Modifications to the Sub-band Partitioning Formulas (Section 16.3.5.2.1 and 16.3.8.2.1)

C802.16m-09/2784

Re: P802.16m/D3 comments for LB30b

Modifications to the Sub-band Partitioning Formulas

Current PHY Structure – 10 MHz

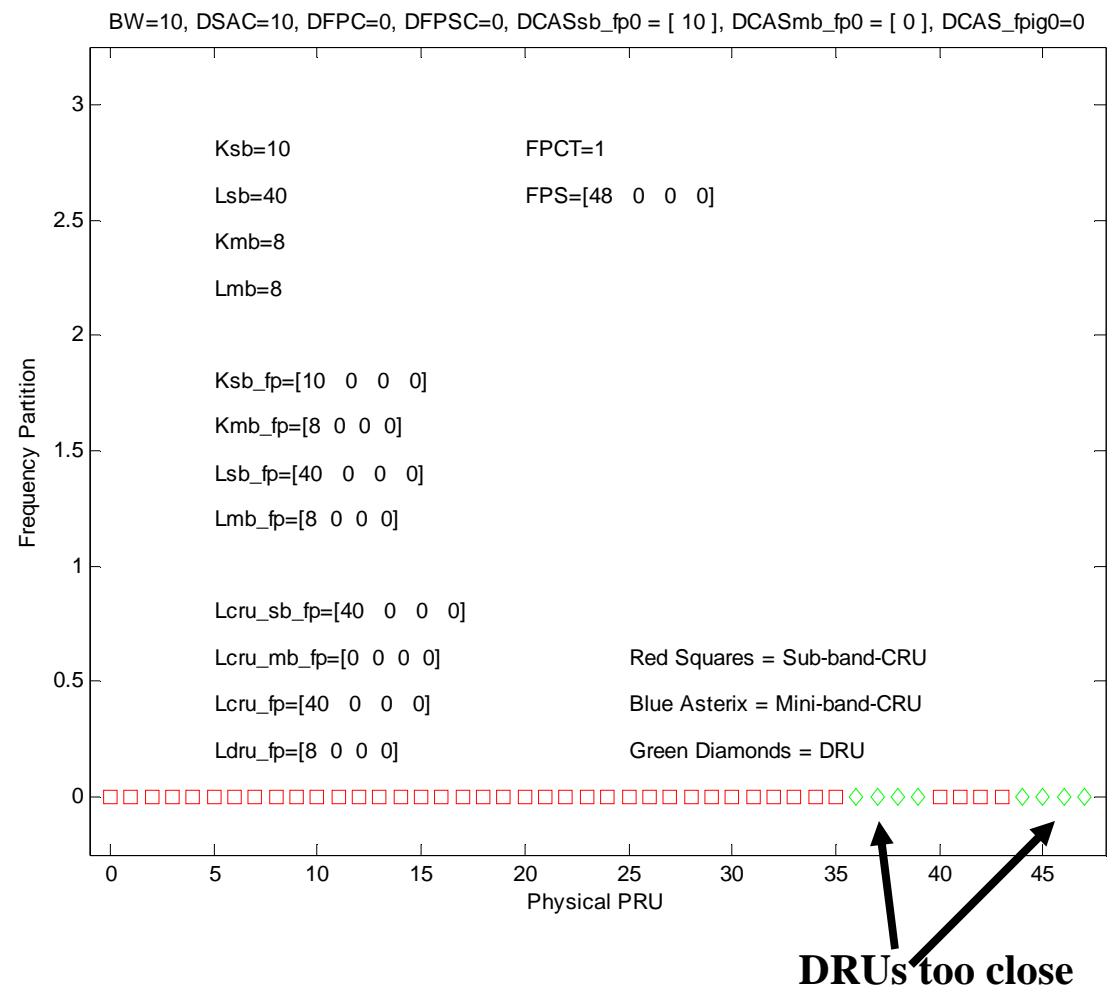
- The A-MAP is required to be transmitted in DRUs
- All subframes are required to have an A-MAP
- When the PHY structure is configured for the maximum allowable number of sub-bands (e.g., the UMi/InH configuration), only a small number of PRUs are allocated to be DRUs
- Those small number of DRUs are poorly placed given the intent to maximize diversity.

- UMi /InH PHY configuration
- The A-MAP is confined to the DRUs
- **Poorly placed for Frequency Diversity**
 - Need wider separation!
- The same problem occurs on the UL for the mini-tile-based DLRUs
- How to fix?

Proposal Overview

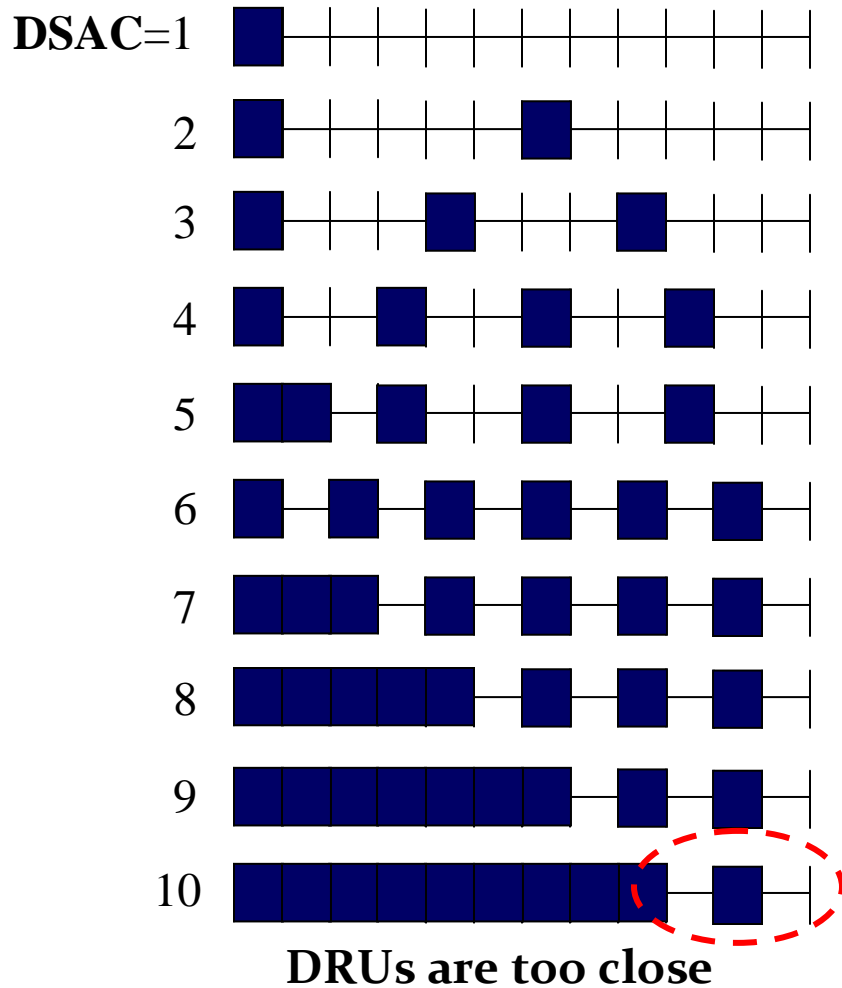
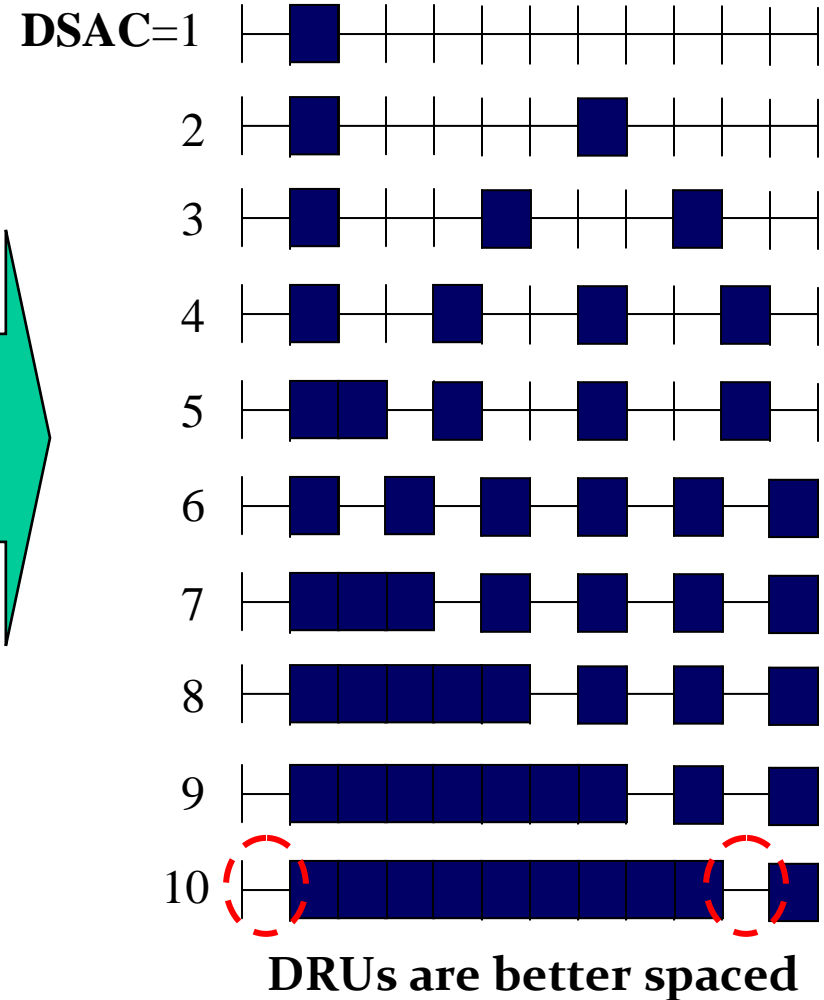
- Perform a right circular shift on the sub-bands

Current

Proposed
